Date: 1st December 1998

Echelon Main LCD backlight driver

T E C H N I C A L B U L L E T I N S H E E T

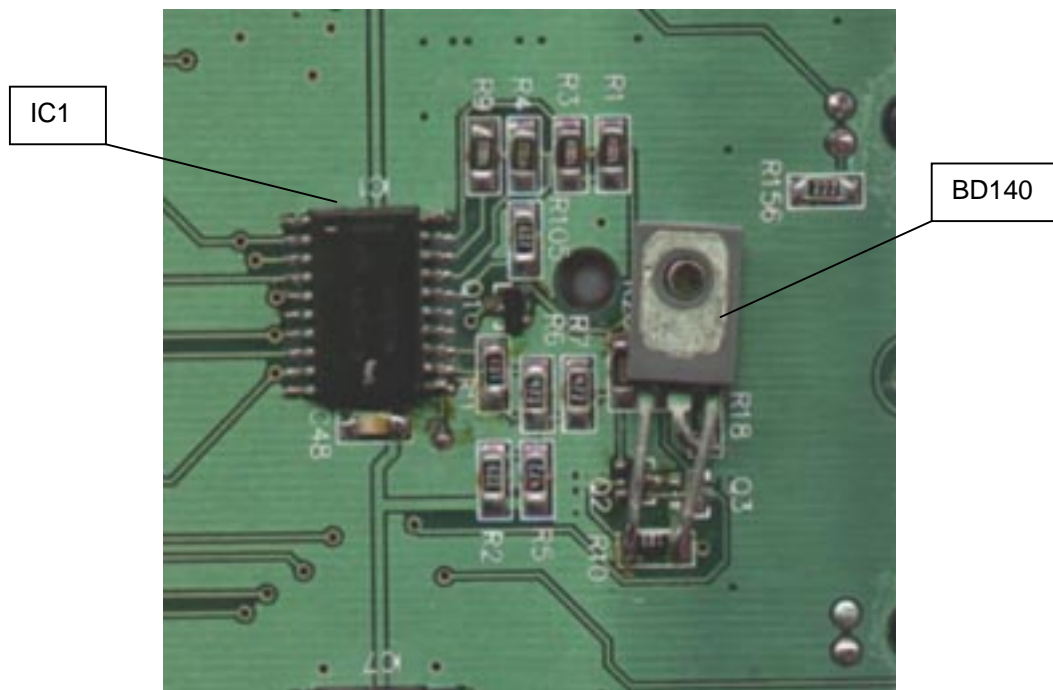
Transistor Q3 may fail prematurely when the main graphics LCD backlight is run at less than 100%, eg when set to either 0, 1 or 2 in the Setup-Panel display.

Echelon consoles with serial numbers up to and including E98343.

Replace transistor Q3 on ECHPROG2 with a BD140. These are available from general electronics part suppliers.

1. On the solder side of the PCB locate the backlight dimmer circuitry close to IC1 (74HC573).
2. Locate and remove Q3 (marked T1p).
3. Locate the end of an M3 bolt that is used to hold the main LCD to the program card. The bolt is nearby Q3.
4. Place the BD140 over the bolt with the metal faced heatsink side upward.
5. Solder the centre lead of the BD140 to the end of R18 furthest from the bolt.
6. Solder the outer leads of the BD140 to either side of R10 such that they don't cross over.

A minor shift in the backlight dimmer levels is be expected due to the different gain of the transistor. The diagram below shows a modified board.
